Yarranabbe Park Masterplan¹ Draft as exhibited, dated May 2011

Background & context

Bike Network Plan – Map

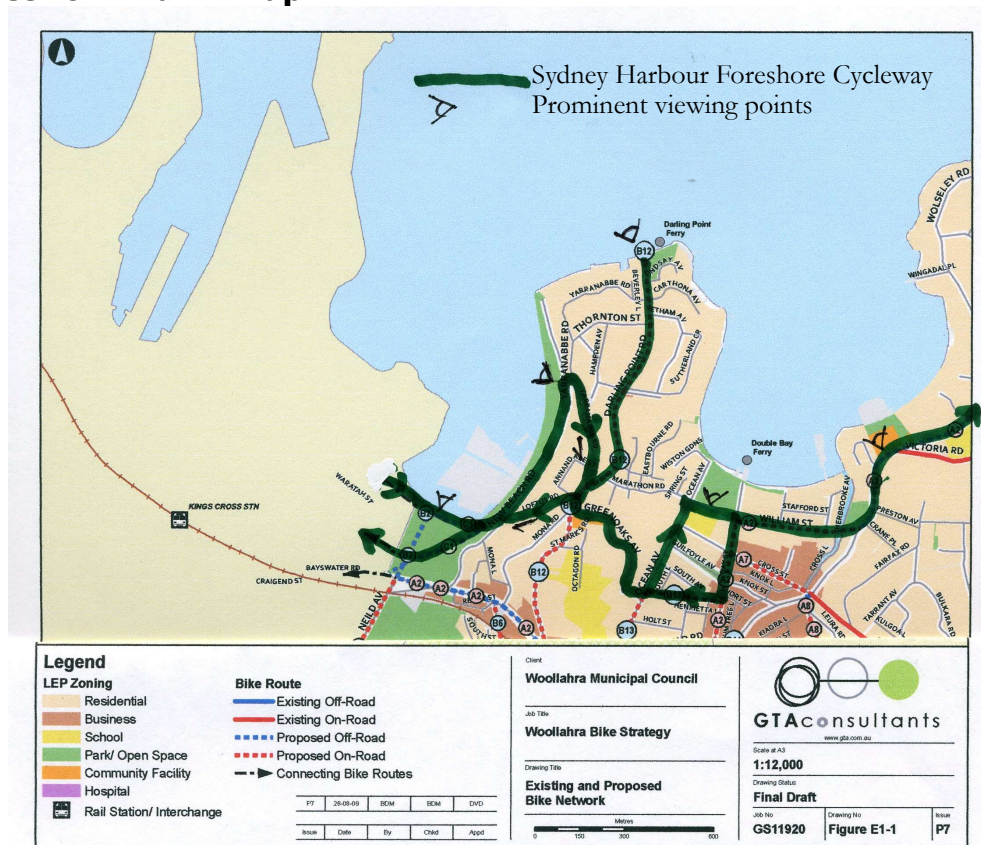
The Bicycle Strategy Bike Network map does not show a specific bicycle route connecting the above two mentioned parks or to and from the ridge of Darling Point. This is despite BIKEast's representations regarding the creation of a **Sydney Harbour Foreshore Cycleway** system that would have made those connections along New Beach Road (see Map and Appendix A, below).

Most of these roads are part of the '*Sydney Harbour Foreshore Cycleway*' designed for regional visitors. The City of Sydney Council is currently implementing the cycleway connections from Elizabeth Bay/Kings Cross, to Rushcutters Bay Park (see Bike Network Plan – Map, above).
